Hilcorp Energy Company plans to recomplate the subject well in the Mesaverde formation and downhole commingle with the existing Gallup and Dakota. Attached is the MV C102, recomplate procedure & wellbore schematic. The DHC application will be submitted and approved prior to commingling. A closed loop system will be utilized.

HILCORP ENERGY COMPANY
SAN JUAN 28-5 UNIT 63E
MESA VERDE RECOMPLETION SUNDRY

RECOMPLETION CONDITION OF APPROVAL

Operator: Hilcorp Energy Company
Lease No.: NMSF 079519A
Well Name: San Juan 28-5 Unit 63E
Well Location: Sec.20, T28N, R05W; 1685' FSL & 1625' FEL

SAN JUAN 28-5 UNIT 63E - CURRENT WELLBORE SCHEMATIC

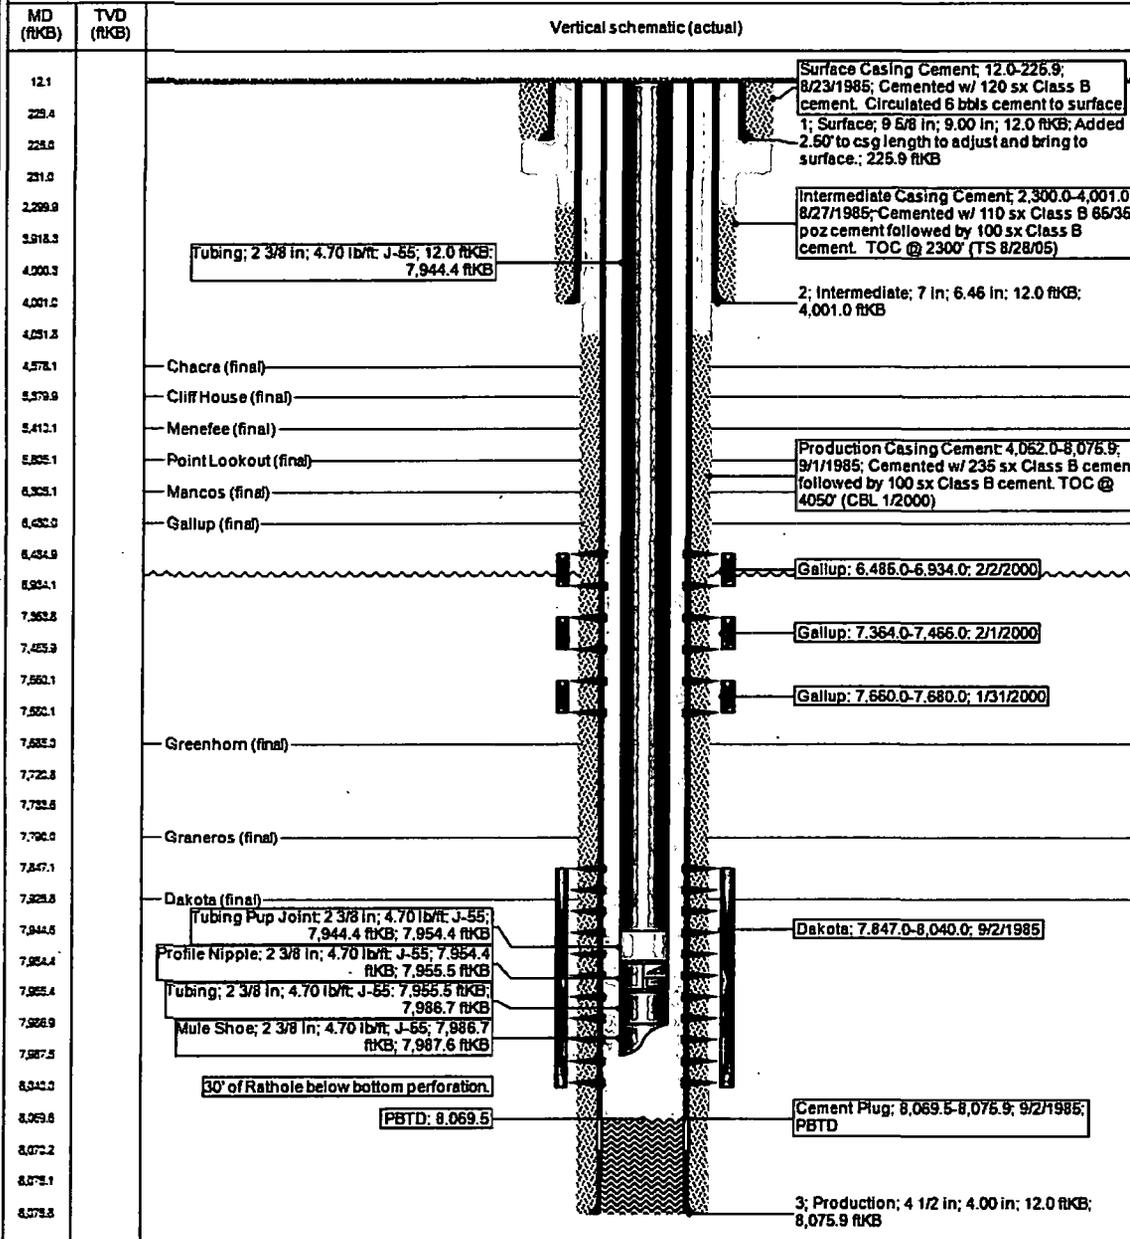
- The recompletion procedure indicates that a CBL was run. Please submit a copy to the Bureau of Land Management – Farmington Field Office (BLM – FFO) for verification.
